SUBJECT: INSPECTION REPORT NO. 70-027/2012-204 AND NOTICE OF VIOLATIONS

REPORT NO.: 70-27/2012-204

LICENSEE: Babcock and Wilcox Nuclear Operations Group, Inc.

BABCOCK AND WILCOX NUCLEAR OPERATIONS GROUP, INC. U.S. NUCLEAR REGULATORY COMMISSION INSPECTION REPORT 70-27/2012-204

Figure 1: Model of Unit Surrounded by 12 Inches of Water

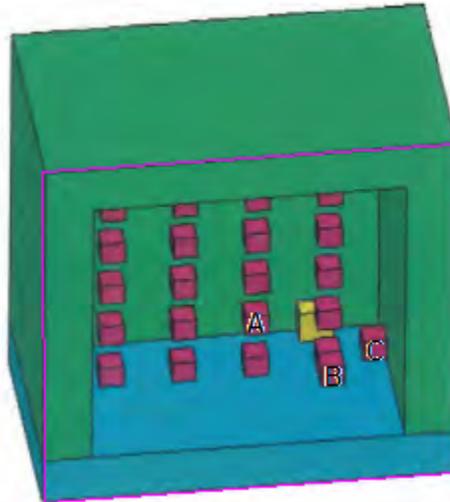
The licensee also analyzed the storage cabinets using an alternate method of accounting for neutron interaction, which can be applied to neutronically isolated units. Until questions from the inspectors lead to the revised analysis, the licensee had not recognized that the license permitted another method of modeling neutron interaction by surrounding a unit in 12 inches of water reflector. This method is discussed in Section 5.2.2 of the license, which states that: “Individual fuel units which are safe by themselves must be evaluated to determine the extent of the neutron interaction between other fuel units in an array. Units will be considered isolated from each other if the increase in K-effective of a unit, due to the presence of another fuel unit, is equal to or less than a K-effective when the presence of an identical unit is separated from the first by twelve inches of water.” As worded, this is not clear as it is comparing “the increase in K-effective” to “K-effective.” It also is not clear how this should be applied. An example of how the licensee modeled the “unit” and the “12 inches of water,” is shown below (adapted from NCS-2012-118, Figure 6). The unit was modeled as being composed of the bread pans in a cabinet (the A blocks), a bread pan in-transit (B block), a bread pan

outside of the room (C block), and a 350 gram ^{235}U unit (the yellow block) to account for material in a nearby room. A reflective boundary condition was applied (the pink face of the model) so that the unit includes 'a mirror image' of the same configuration for the other cabinet. The unit was placed on a concrete floor (blue material) and surrounded by 12 inches of water (green material).

With this alternate method of modeling interaction, the new bread pan design would still meet the Safety Limit because the worst-case upset would not exceed the 0.95 limit. In addition, the normal case is below 0.92. Therefore, the licensee retracted the EN on August 6, 2012.

Because questions have been raised about the meaning of license commitments and because a more widespread review of the use of "permitted as necessary" controls is warranted, this will be treated as an URI. **URI 70-27/2012-204-03** tracks the implementation of the "permitted as necessary" administrative control on interspersed moderation without the establishment of specific limits, and the adequacy of the control, given modeling assumptions.
